CONSTRUCTION PLANS FOR CARRIAGE MEADOWS SOUTH AT LORSON RANCH

STREET, STORM SEWER, AND POND CONSTRUCTION PLANS

COVER SHEET
STREET, STORM SEWER AND POND
CONSTRUCTION PLANS

DATE: MARCH, 2017
 PROJECT NO. 100.030
 SHEET NUMBER **C6.12**
 TOTAL SHEETS: 37

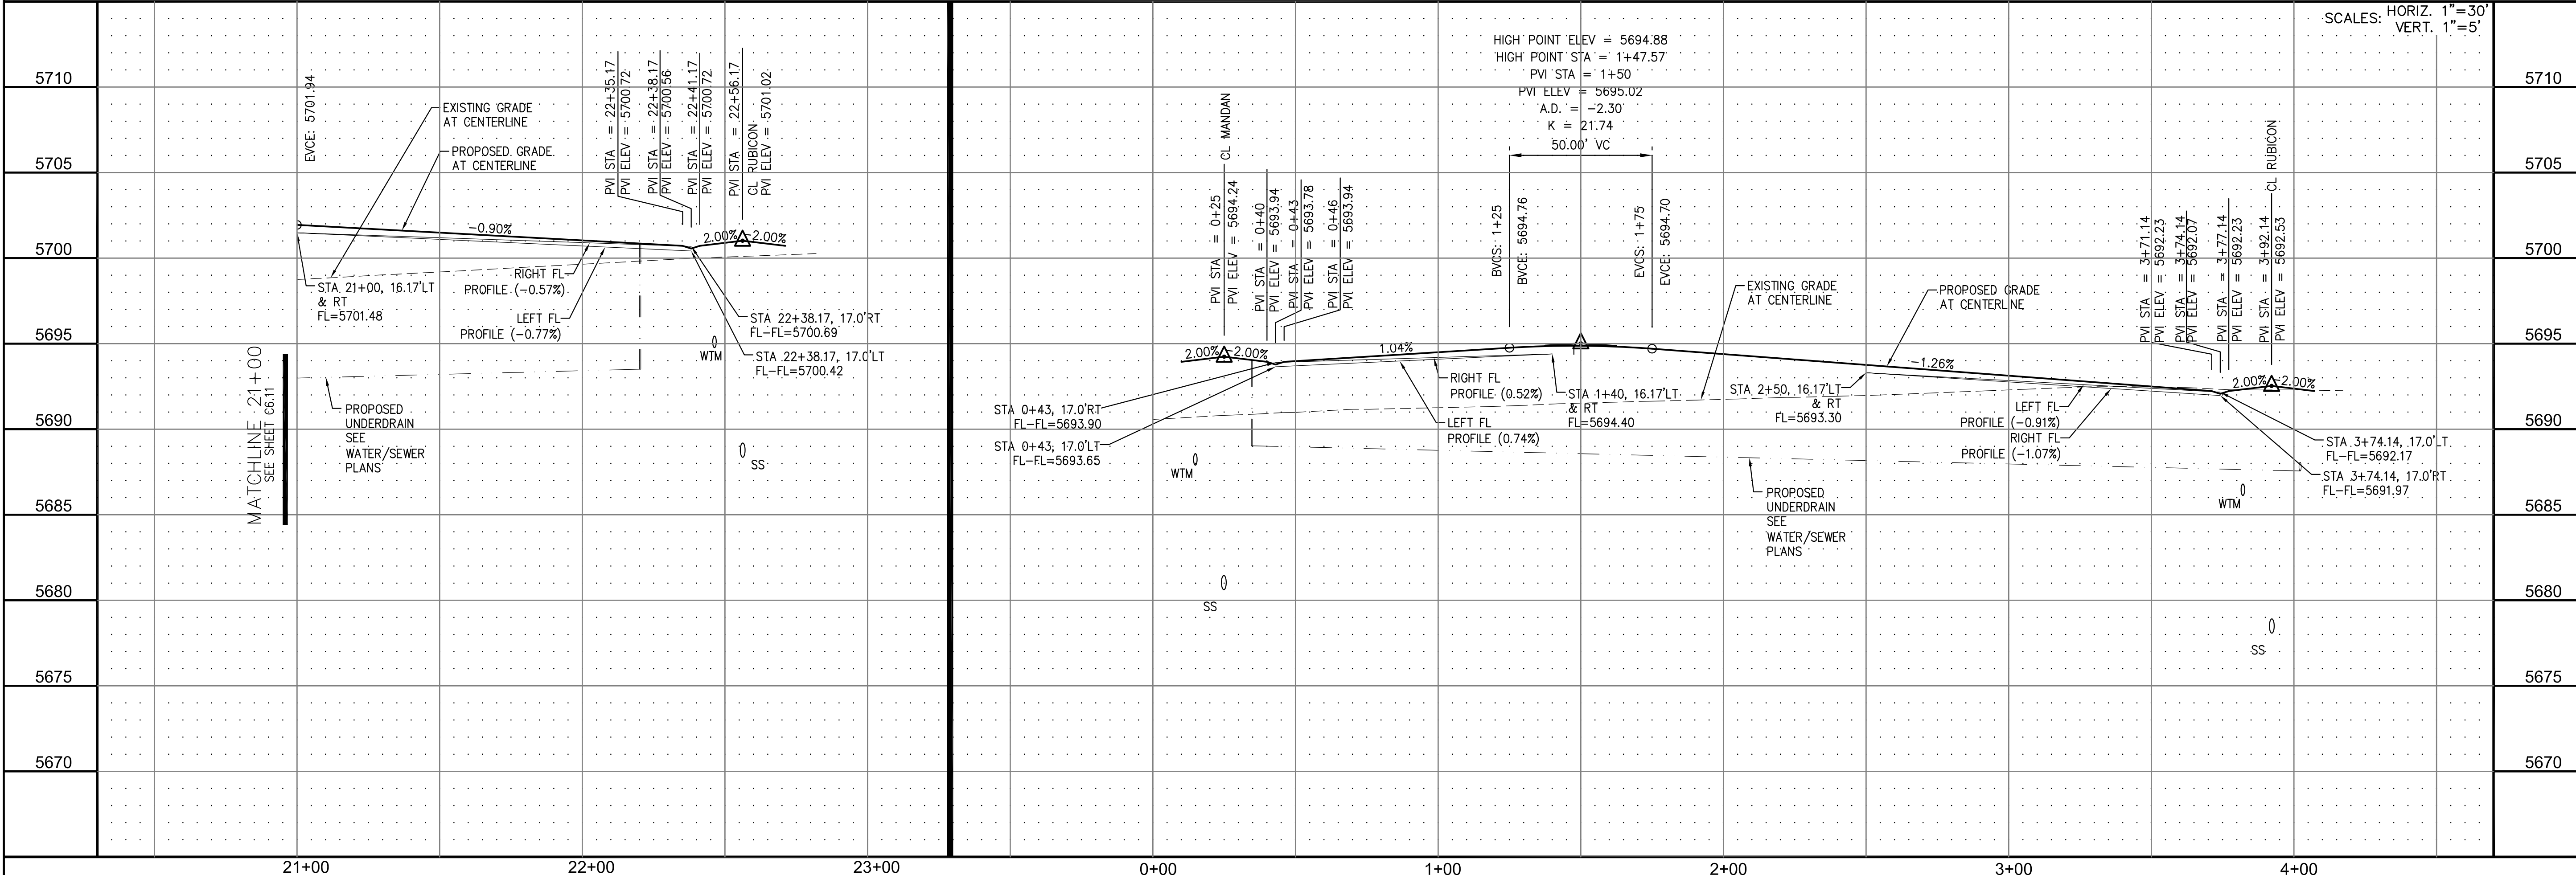
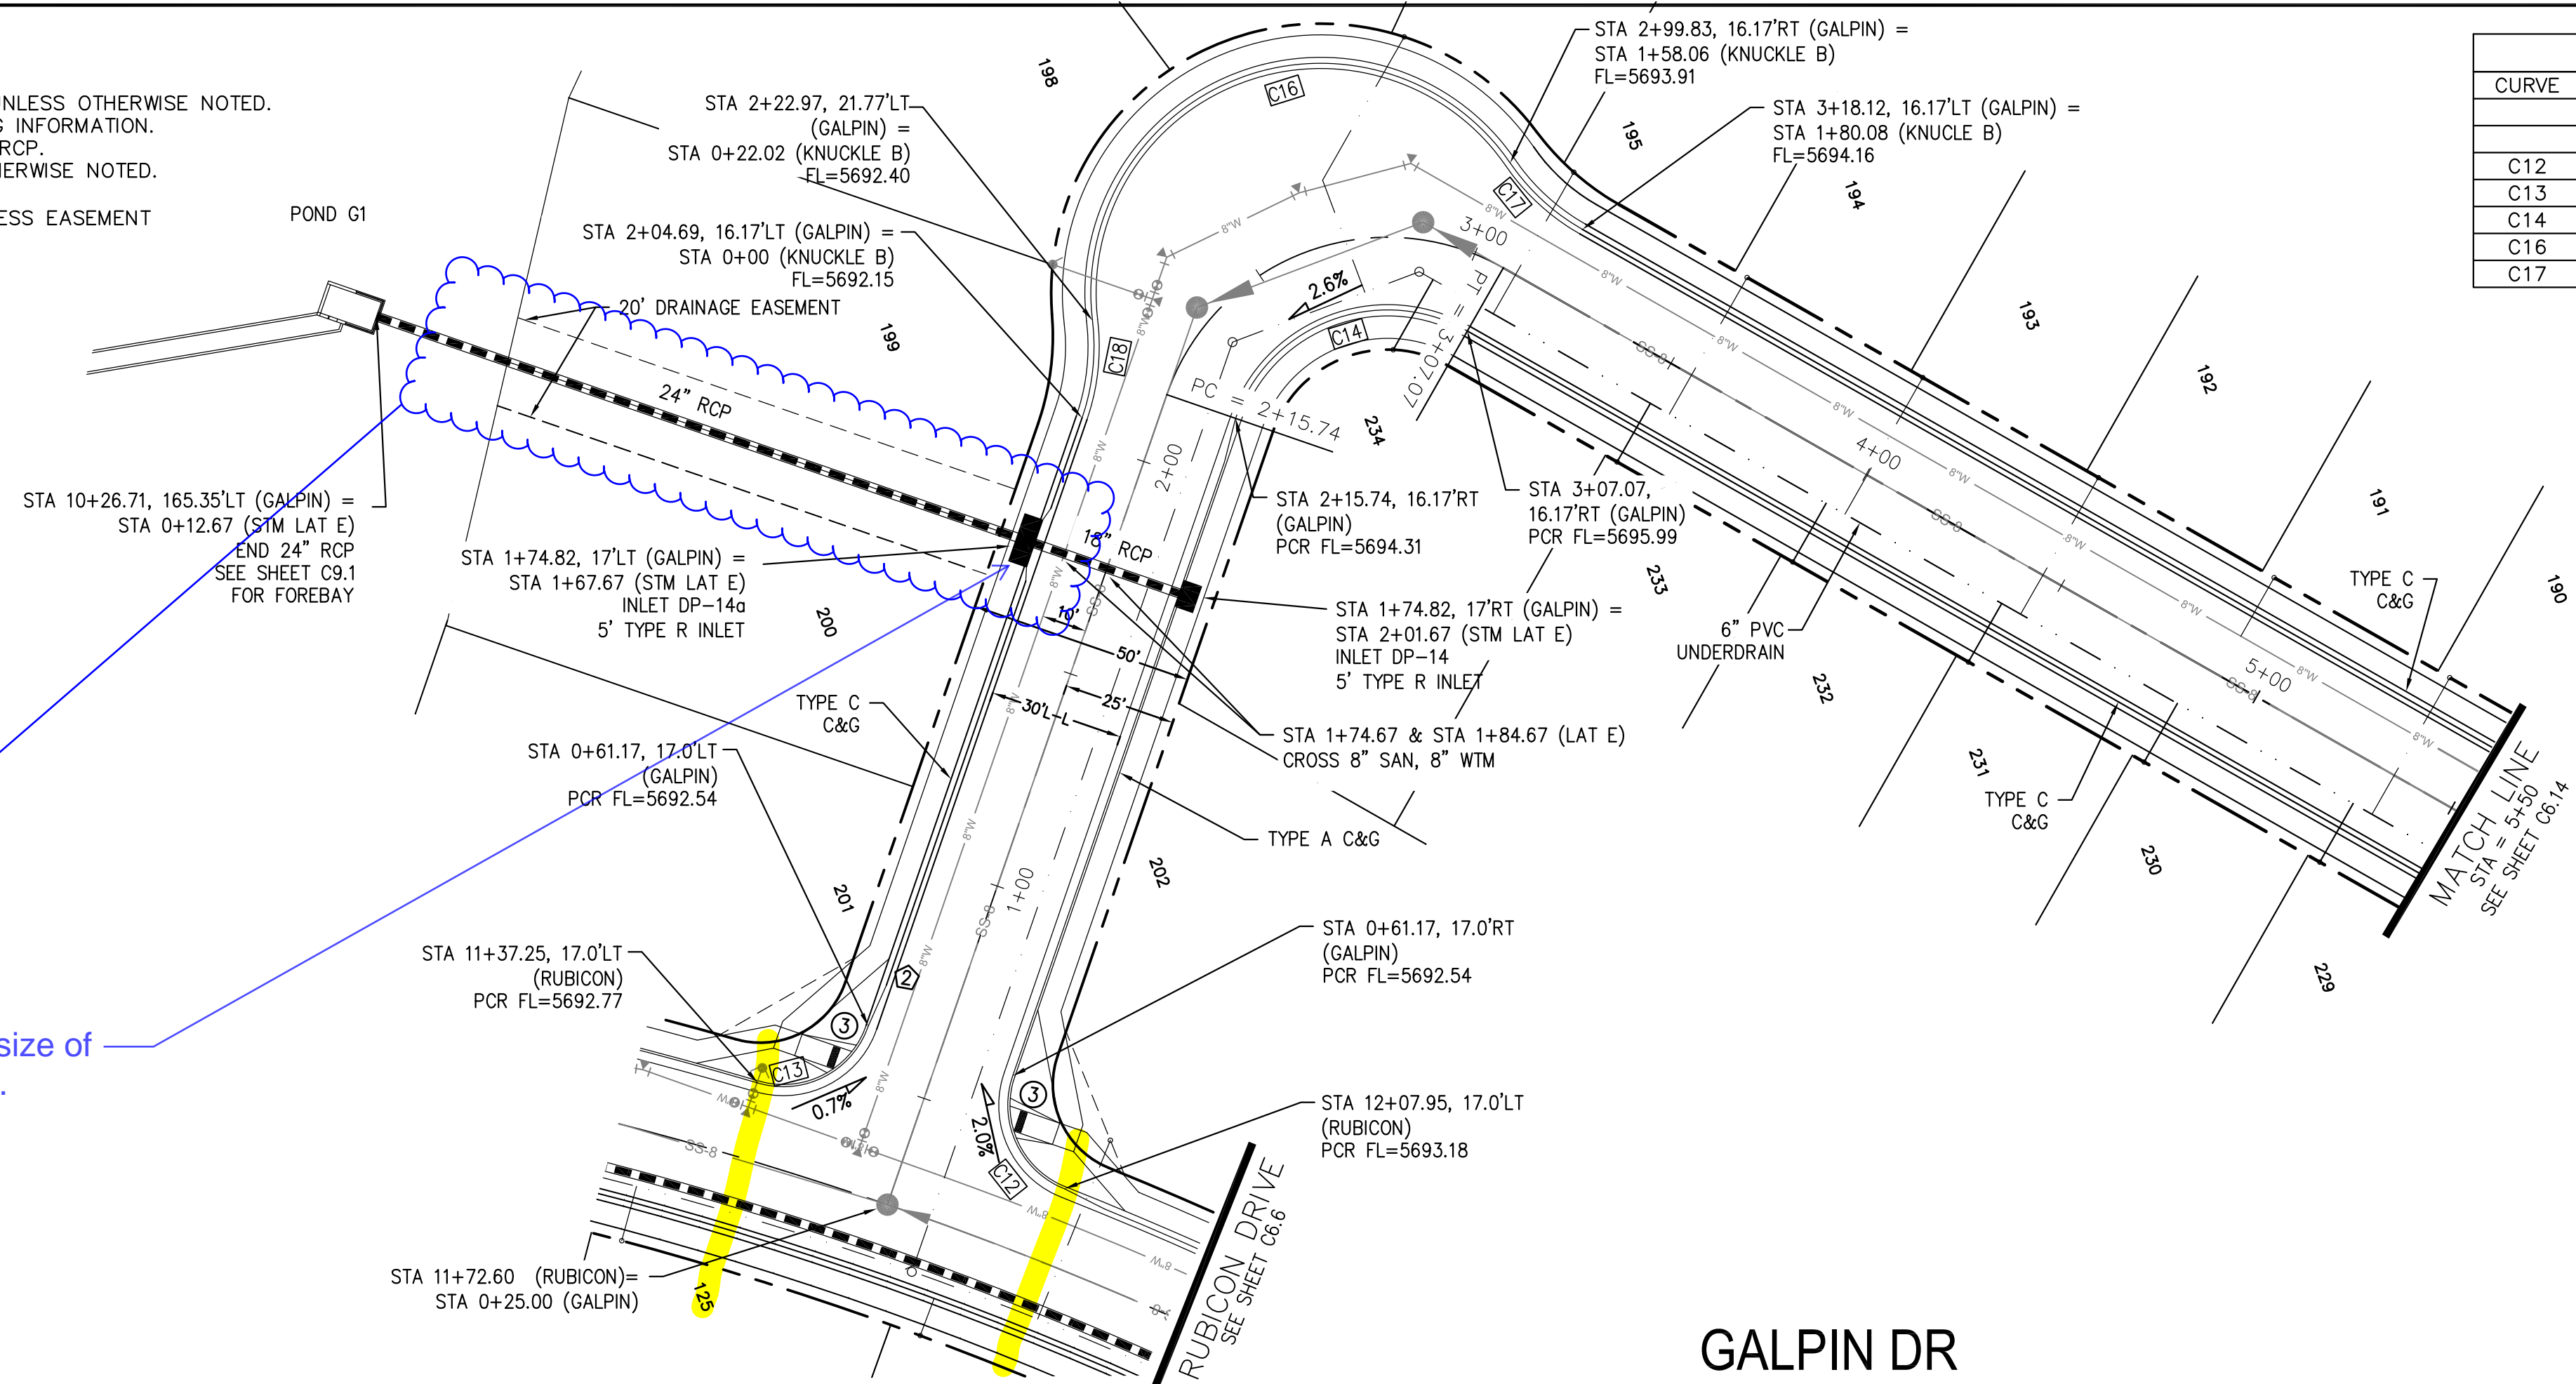
Please show southerly lot line.

DATE: MARCH, 2017
 PROJECT NO. 100.030
 SHEET NUMBER **C6.13**
 TOTAL SHEETS: 37

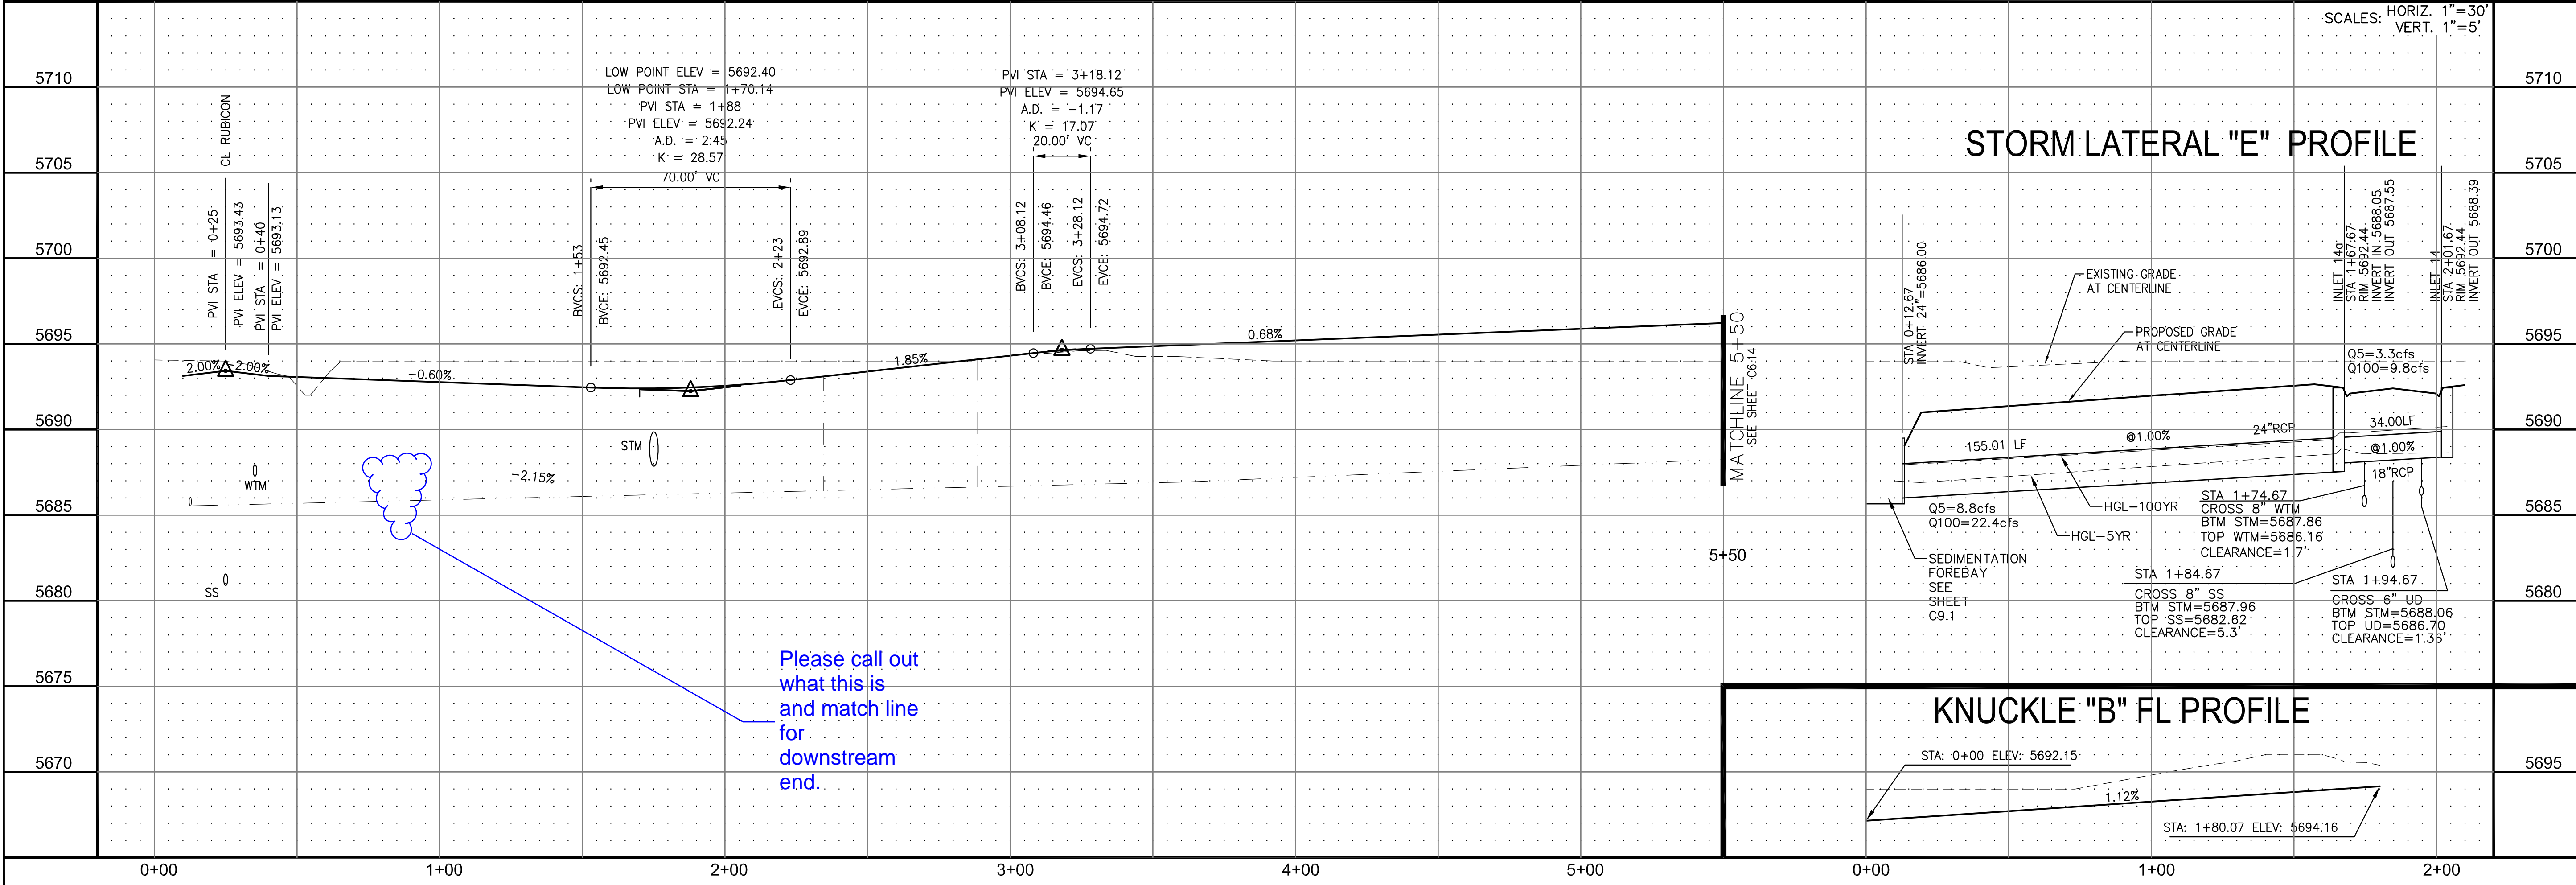
Please clarify if this is centered on the property line.

Please call out what this is and match line for downstream end.
